# Access Compliance Report

## Public Rights-of-Way

### (Curb Ramps)

Intersection ID: 11157	Main Street: N_IRWIN_AV	Cross Street: W_6TH_ST	Location: W
ADA ID: 69465F7C2B85	Ramp Type: Directional1	Initial Pass/Fail: Pass	Overall Compliance: No
			Severity Score: 5

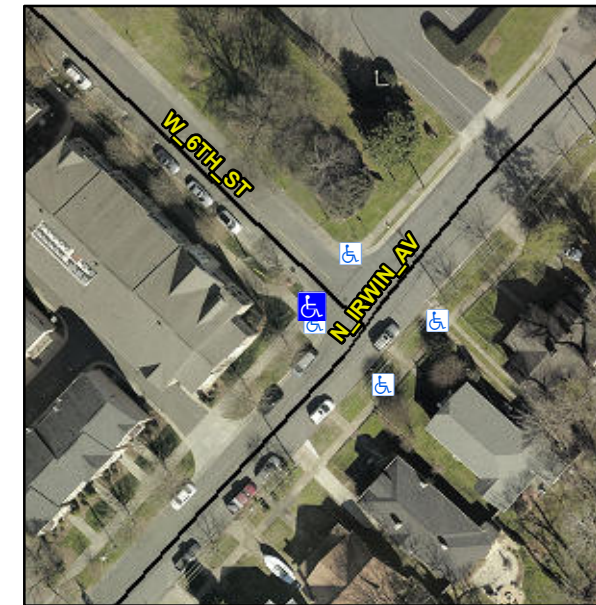
**Not Found, R304.2.2-Perp, R304.3.2-  
Para, R304.2.3, R304.5.3**

Compliance	Description	Data	Compliance	Description	Data
N/A	Ramp Length (in)	47.0	Yes	Grade Break?	Yes
Yes	Ramp Width (in)	71.0	Yes	Grade Break Slope (%)	5.0
Yes	Ramp Slope (%)	7.9	Yes	Grade Break XSlope (%)	2.0
Yes	Ramp XSlope (%)	0.9			
No	Flare Type LT	N/A	N/A	Flare Type RT	N/A
N/A	Flare Slope LT (%)	N/A	Yes	Flare Slope RT (%)	4.1
N/A	Flare Traversable LT?	No	N/A	Flare Traversable RT?	Yes
Yes	Landing Length (in)	71.0	Yes	DWS Provided?	Yes
Yes	Landing Width (in)	71.0	Yes	DWS Contrast?	Yes
No	Landing Slope (%)	2.4	Yes	DWS Length (in)	24.5
Yes	Landing X Slope (%)	0.2	Yes	DWS Full Width?	Yes
N/A	Landing Curb? (Y/N)	N/A	Yes	DWS Offset LT (in)	0.0
N/A	Shared Landing?	Yes	Yes	DWS Offset RT (in)	26.0
Yes	Gutter Ponding?	No	Yes	Gutter Slope (%)	2.8
Yes	Gutter Lip Ht (in)	0.0	No	Gutter X Slope (%)	4.7
N/A	Painted X Walk1?	No		Road Slope (%)	1.0
	X Walk 1 Direction	To NE		Road X Slope (%)	1.1
	X Walk 1 Width (in)	N/A		Clear Space?	Yes

**Remove & Replace Entire Ramp.  
Remove & Replace Gutter.**
